VA24-01; REZ24-01; REZ24-03; & PUD24-03 145 S. Morristown Pike McNeely Law LLP as applicant; William Eric Group, LLC as owner, request a zoning recommendation of “RL” Residential Low Density District, “PUD” Planned Unit Development District, & “PK” Park District Zoning Designations for 169.513 acres +/- collectively upon Greenfield City Council annexation approval. The Property is not yet zoned.

ADDENDUM SUBMITTED FEBRUARY 11, 2025

Staff Report Addendum for February 11, 2025 Plan Commission meeting

Exhibit 1. Villas at Hawks Tail PUD Statement Final 1-21-25

LOT COVERAGE
EXHIBIT

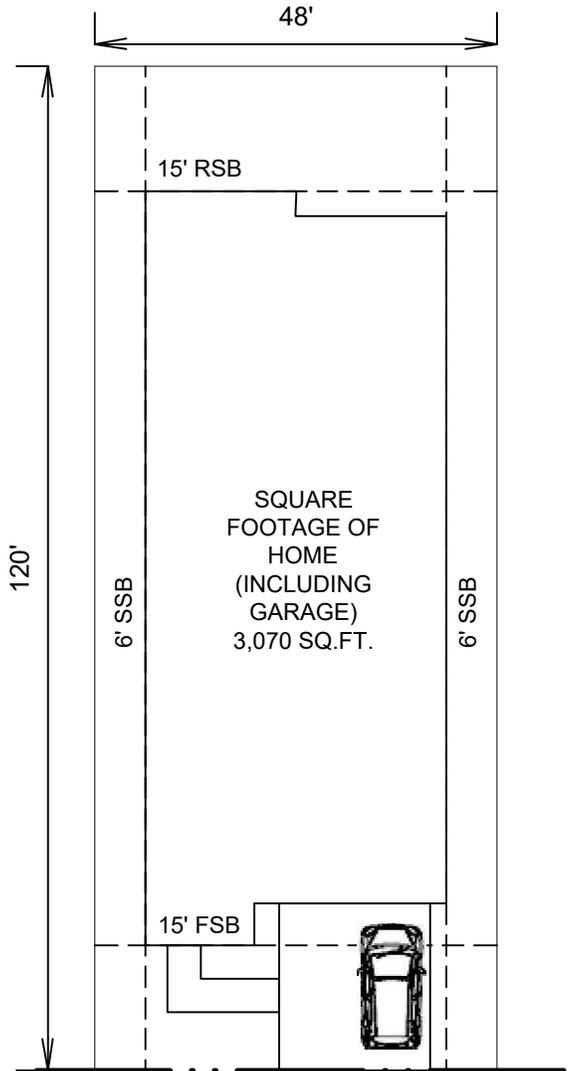
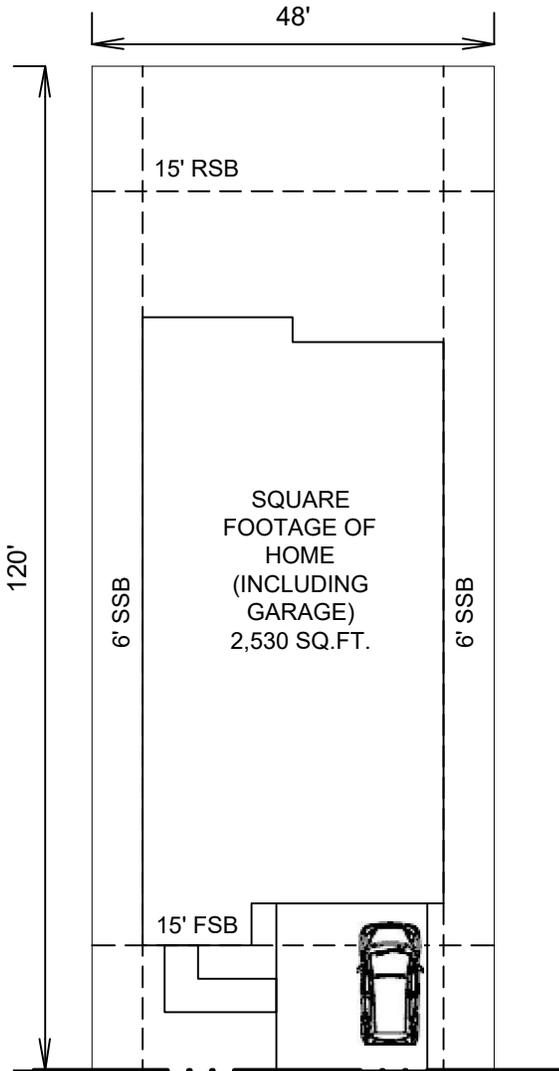
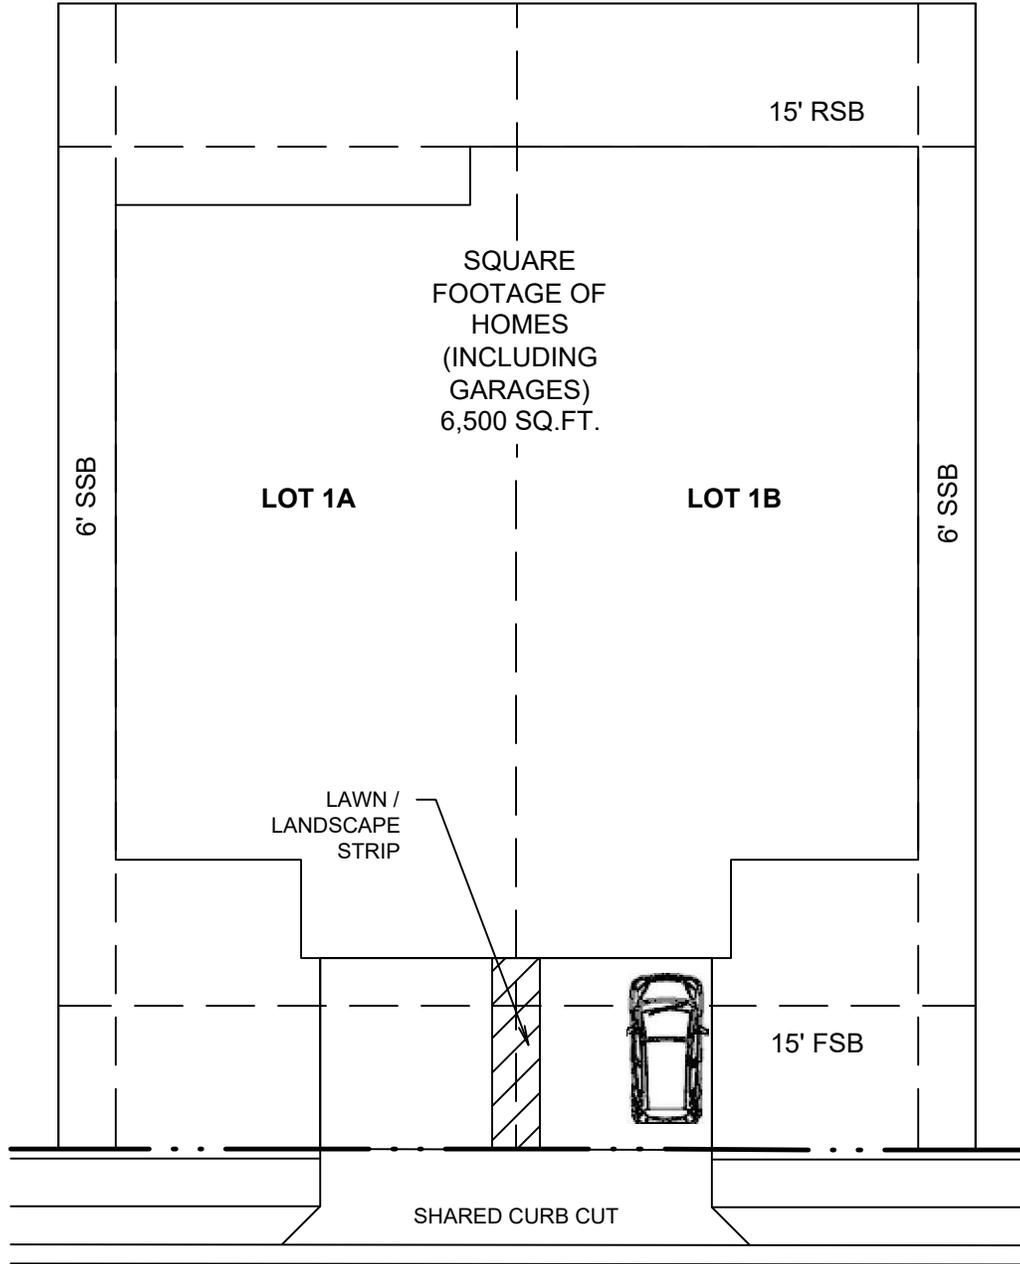
1. **Request:** Lot coverage exhibit - show all dimensions of lot and house footprint for 45%, 55% and 65% lot coverage on both SF and Paired lots.
 - a. **Petitioner Response**

- b. **Findings:** The single-family lots are not big enough to provide any more than 60% lot coverage at maximum building size. The paired villas can maximize lot coverage at 65% because of the shared wall. Both 60% and 65% on each lot type leave only the minimum 15-foot back yard. While only a rear stoop at the door is required by the Building Code, decks and patios could be within a few feet of the neighbor's deck or patio. In addition, staff is concerned that the small lot will require steeper than normal grades away from the house leaving little useable yard. Staff recommends 55% lot coverage for both single family and paired villa homes to stay in line with the maximum lot coverage allowed in the UDO for any 1 or 2 family home, and to allow decks and patios to be built in a comfortable space.

- i. Ex a. showing 50% lot coverage with a single-family home of 2,530 sq. ft., and 60% lot coverage with a single-family home of 3,070 sq. ft.
 - ii. Ex. b showing 65% lot coverage for a paired villa with each villa being approximately 3,250 sq. ft.

SHARED DRIVEWAY
EXHIBIT

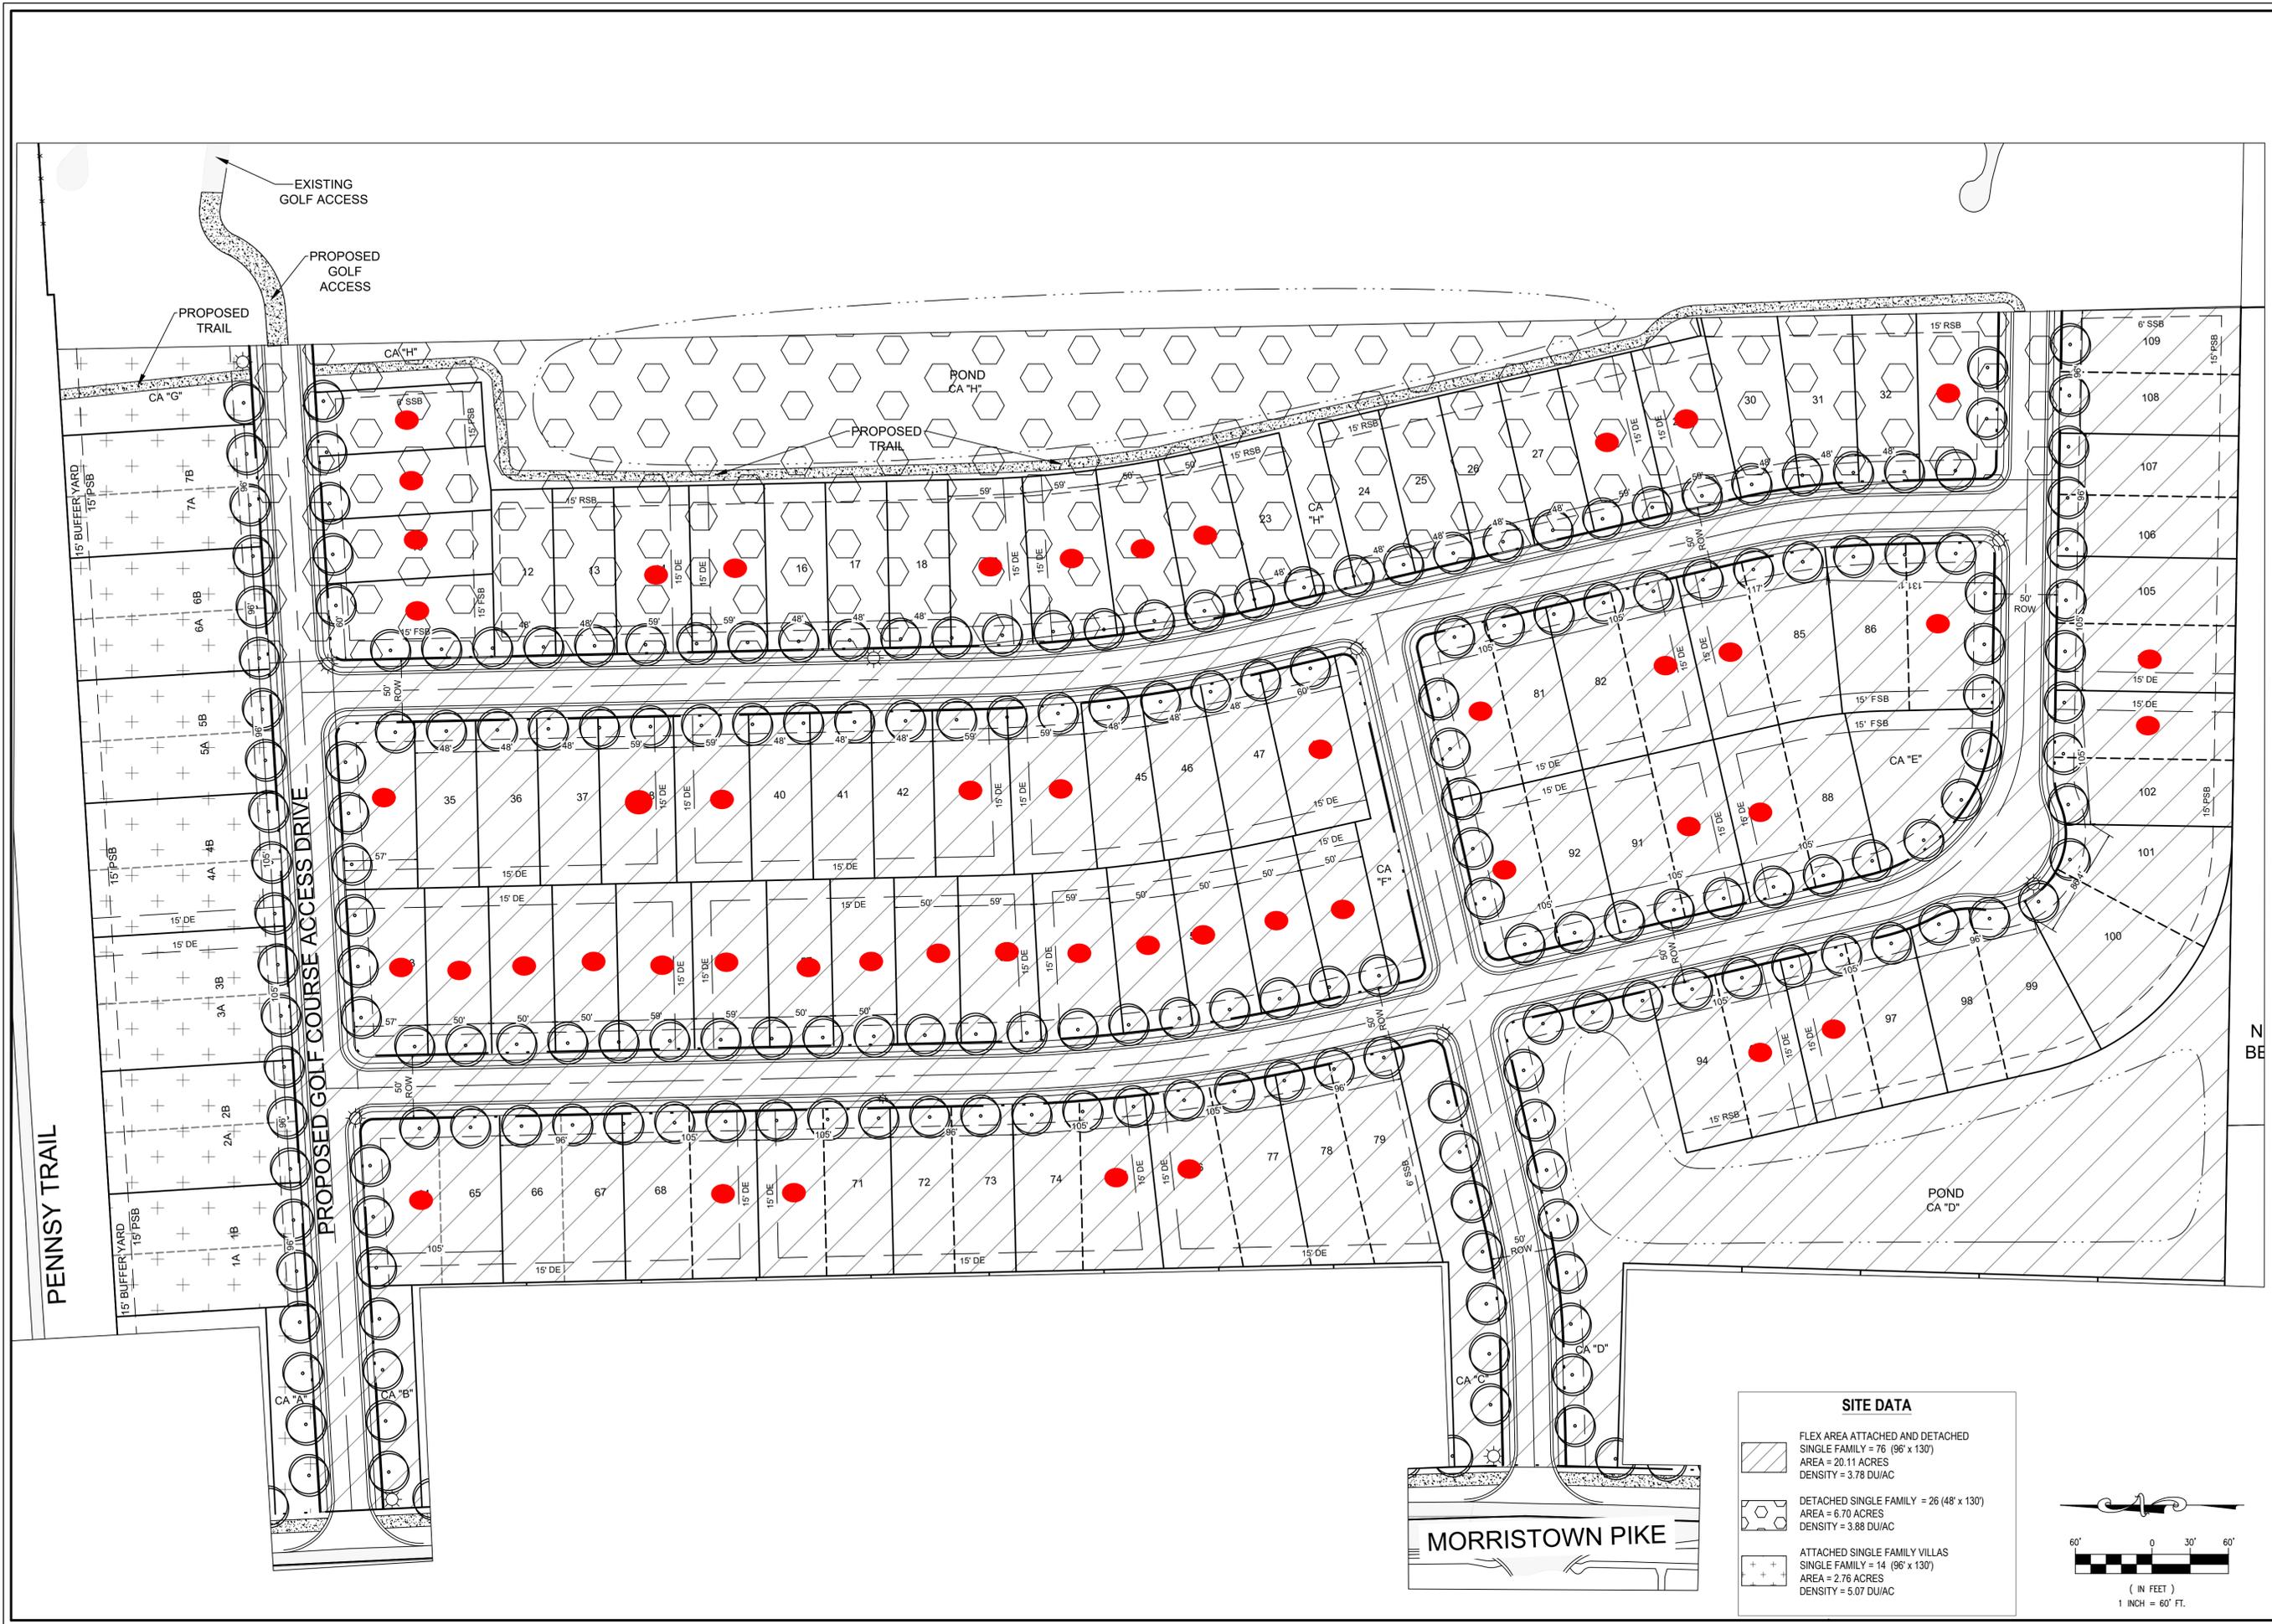
6. **Request:** Connected driveway exhibit
 - a. **Petitioner response:** Exhibit b indicates a shard driveway for paired villas will have one curb cut but two driveways and apparently, will still provide a landscape strip between the two driveways as is typically how these connected driveways are constructed.

- b. **Findings:** - agree as submitted
